Airworthiness Directive Issuance Form

AD No.: 2023-0136R1

Revision: This AD revises EASA AD 2023-0136 dated 12 July 2023, which superseded EASA AD 2022-0243 dated 08 December 2022.

ATA 36 – Pneumatic – Overheat Detection System Sensing Elements – Inspection

Figure 4-50. Identification Markings on Coaxial SE Male (Pin) Connector

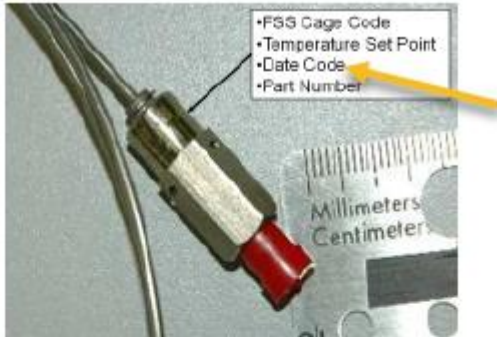
Affected part: Overheat detection system (OHDS) sensing elements, also identified as 'Continuous Fire Detector', having a Part Number (P/N) and corresponding date code as listed in Section 1.A of

Appendix 1 of this AD provides information how to identify affected parts (P/N and date code).
